**INDIANA DEPARTMENT OF TRANSPORTATION**
*Driving Indiana's Economic Growth*

## June 17, 2010 Standards Committee Meeting

RE: Minutes for the June 17, 2010 Standards Committee Meeting

ADDED FIGURE *77-4H TYPICAL WIRELESS VEHICLE DETECTION SYSTEM DESIGN (DRAFT)*

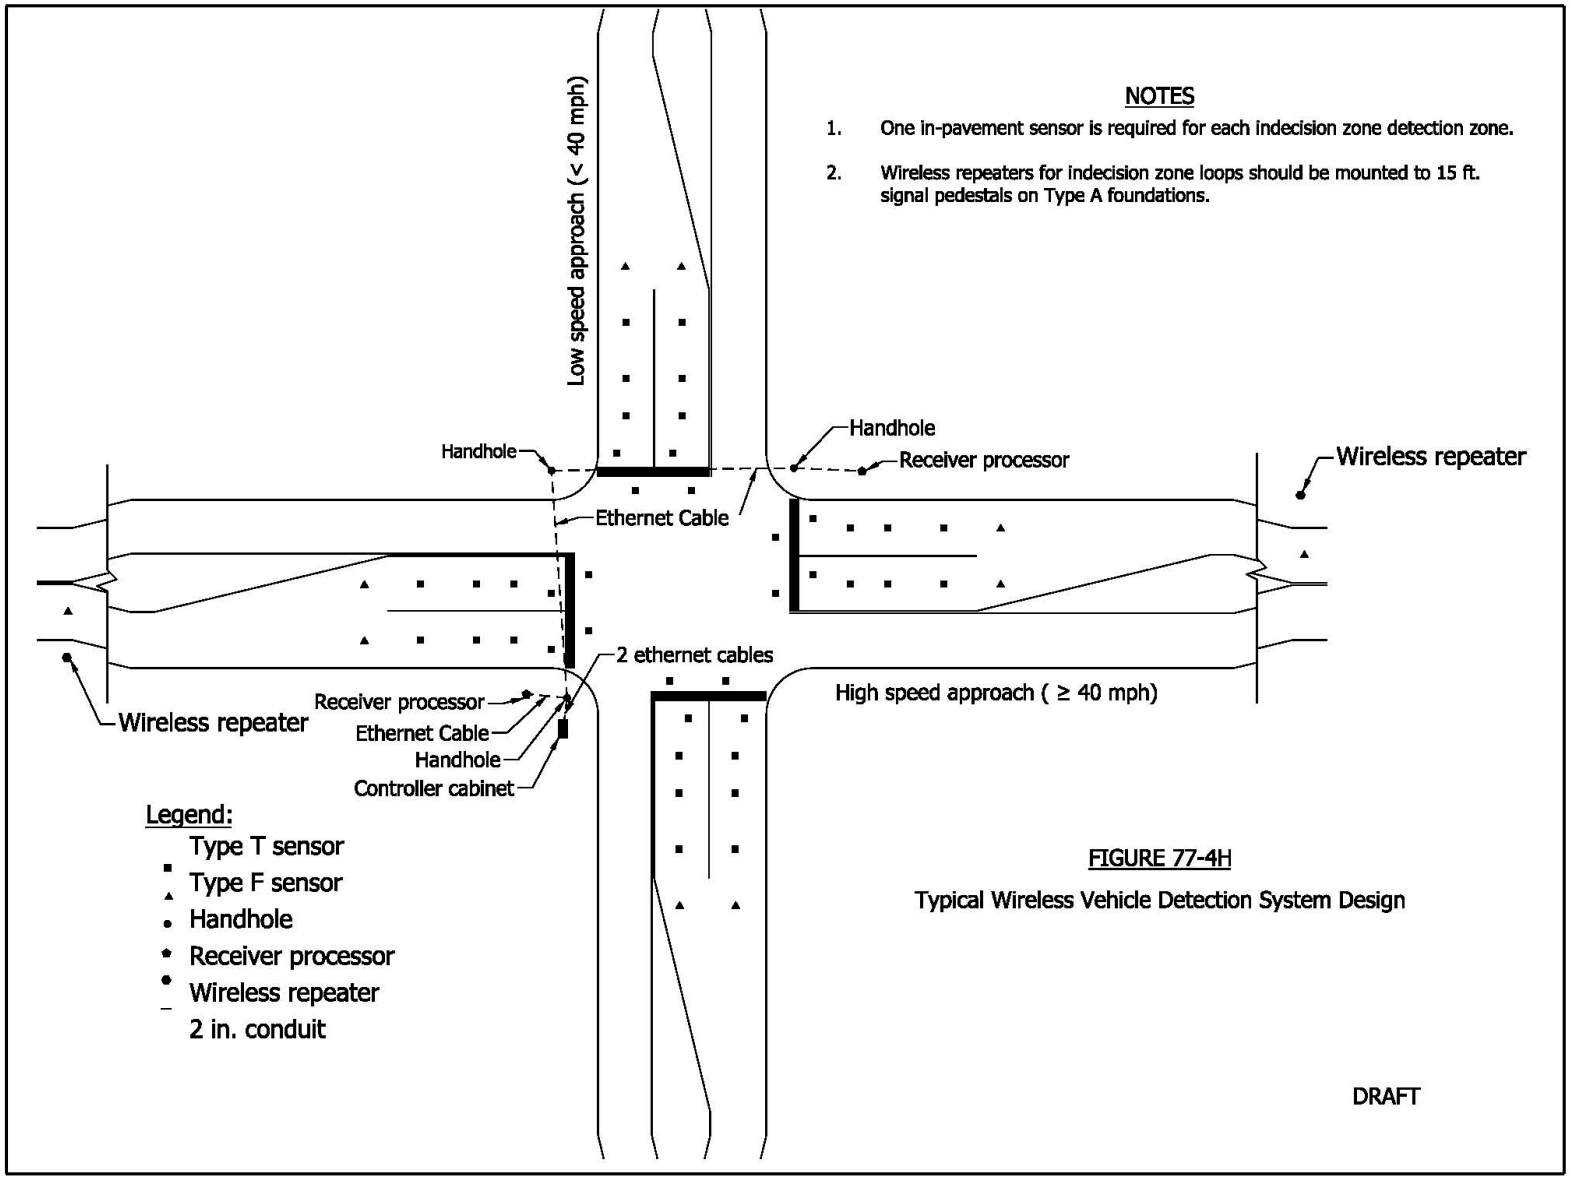
*intersections should be mounted to signal structures. The ethernet cable for the receiver processors may be run across span wire on span and strain pole installations. Wireless vehicle detectors are sufficiently sensitive to detect bicyclists or for use as a counting device. One of the disadvantages of wireless vehicle detector is that they have to be replaced, at least every 10 years, and the wireless repeaters' batteries have to be replaced every 2 years. See Figure 77-4H and Figure 77-4I for typical installation designs.*

*Detection systems other than inductive loops require plan detailing. See Figures 77-4H and 77-4I for typical plan details. In order to use a type of detection other than inductive loops, INDOT designers and consultants and local agency consultants must provide and submit documentation that 2 of the following 3 conditions have been met:*

PROPOSED NEW STANDARD DRAWING *805-SGDW-01 WIRELESS VEHICLE DETECTORS STOP BAR DETECTION ZONE* (DRAFT)

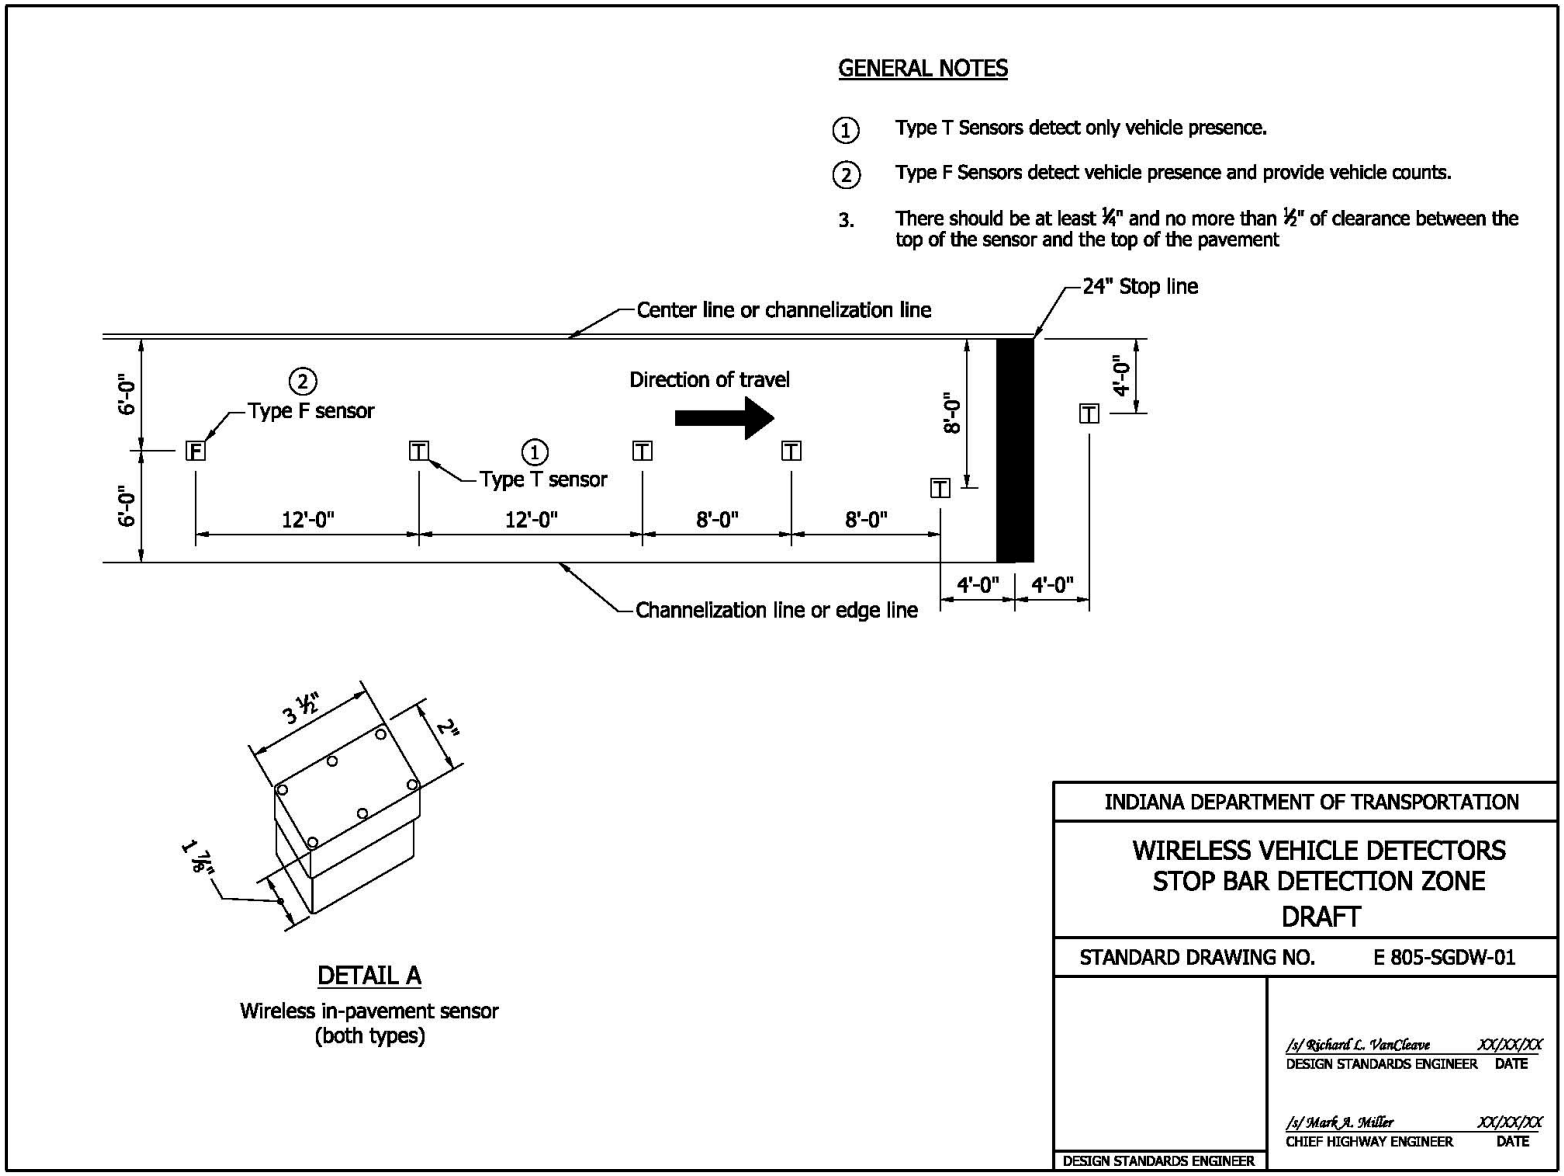
Mr. Keefer asked about the life of the batteries especially in the detectors and the answer was that the detector batteries lasted about 10 years in the detectors and 2 years in the repeaters. Mr. Keefer then asked if other states were using this technology. The answer was that there are other states as as well as our use of it on SR37 in Noblesville.

Mr. Andrewski asked if there was proof that the batteries lasted for the stated timeframes and if there was any way to track how long the batteries had been in place. Mr. Richards stated that the company had not been around for 10 years yet so the detector battery life was an estimate at this time ad there is a program to track the various intersections throughout the state and this could probably be added to that program.

Mr. Miller asked if intersection would revert to a timer if there was a detector failure and the answer was yes.

Mr. Andrewski asked what the cost to replace the batteries was and who would be responsible for the replacement cost and labor. Mr. Richards stated that the repeater batteries were approximately $80 each and the detectors had to be completely replaced at a cost of $400-$500 each. The cost would come out of the traffic management budget and the work would be performed by maintenance crews.

| Motion:<br>Second:<br>Ayes:<br>Nays: | Action:<br>____ Passed as Submitted<br>____ Passed as Revised<br>_X_ Withdrawn |
